Village of Chenequa Plan Commission
Monday, February 12, 2024 at 6:00 p.m.
31275 W. County Road K, Chenequa, WI 53029

STAFF REVIEW

Subject: Site Plan Review

Project Description: Proposed Remodel/Addition to a Legal-Nonconforming Structure

LANDSCAPE
PLAN

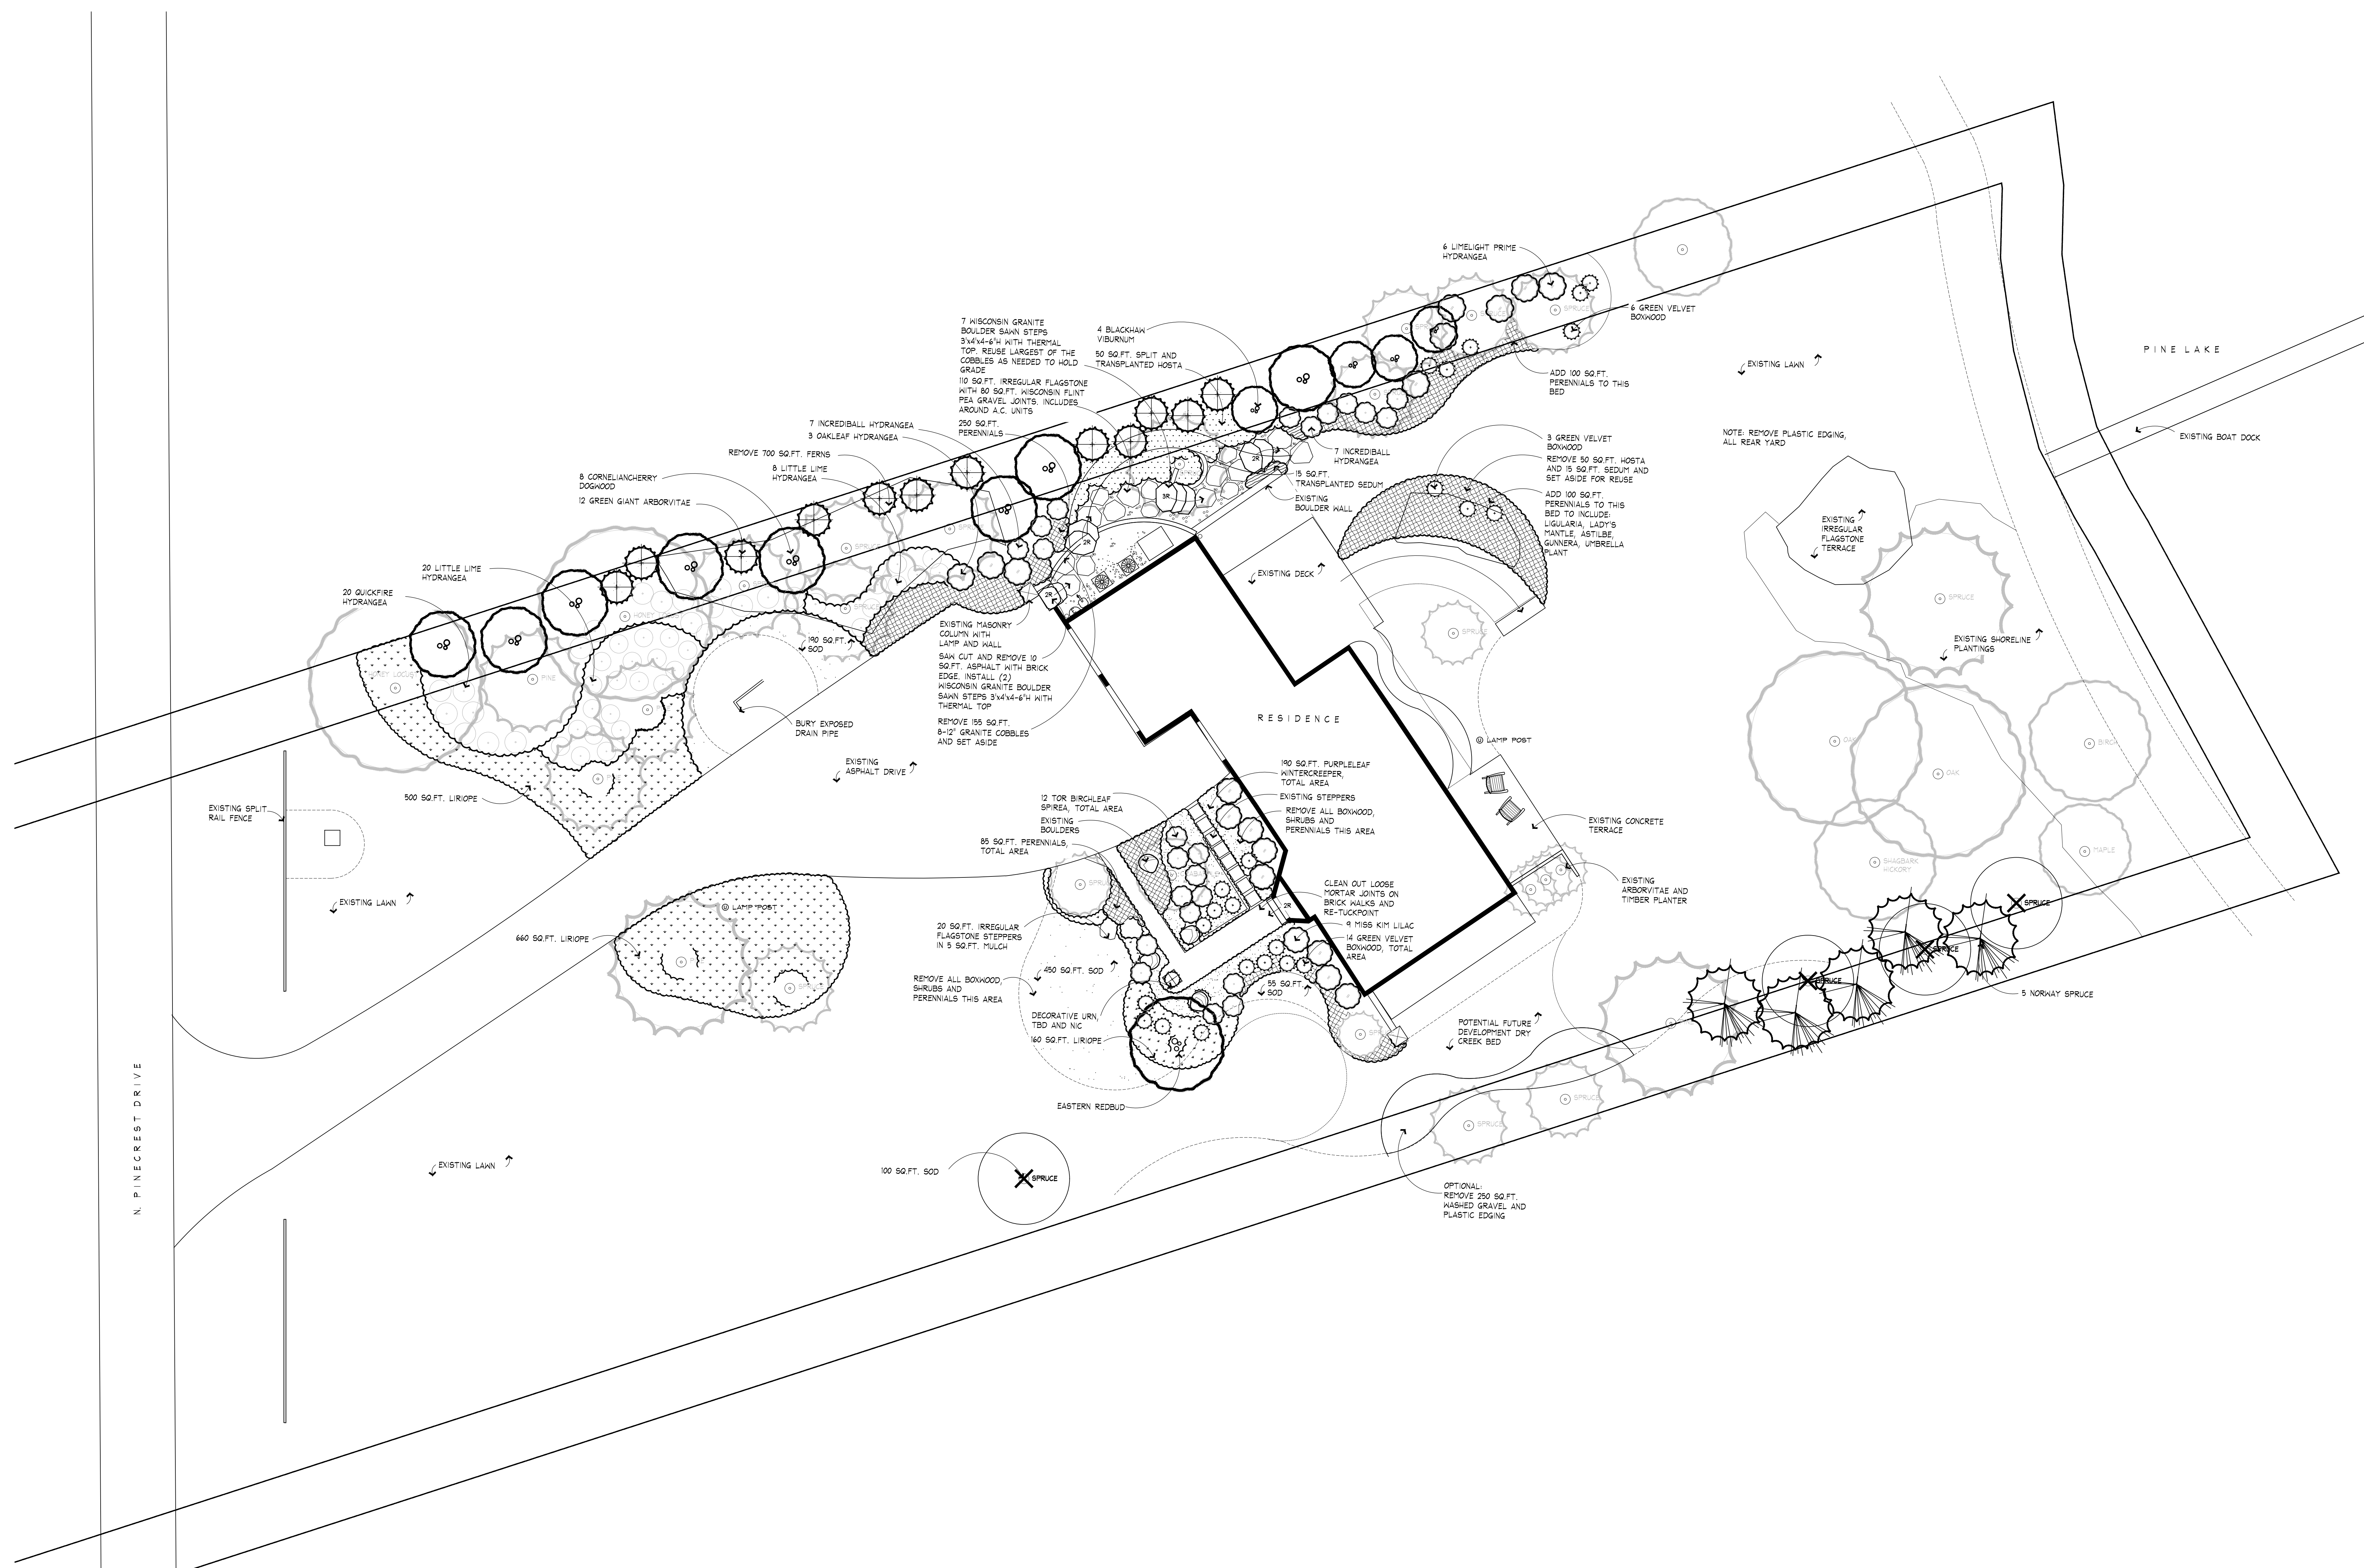
1. The applicants propose to install hardscaping and soft scaping around the existing primary dwelling.
2. This is a legal conforming lot
3. This proposed project includes:
 - a. Re- tuckpointing the existing brick walkway up to the primary residence entrance.
 - b. Adding a flagstone walkway with granite boulder steps along the north property boundary (see photo book for samples)
4. Planting an assortment of trees, shrubs and grasses around the property (See landscape plan prepared by Scott Byron)
5. Photos of materials to be used have been supplied in your packets.
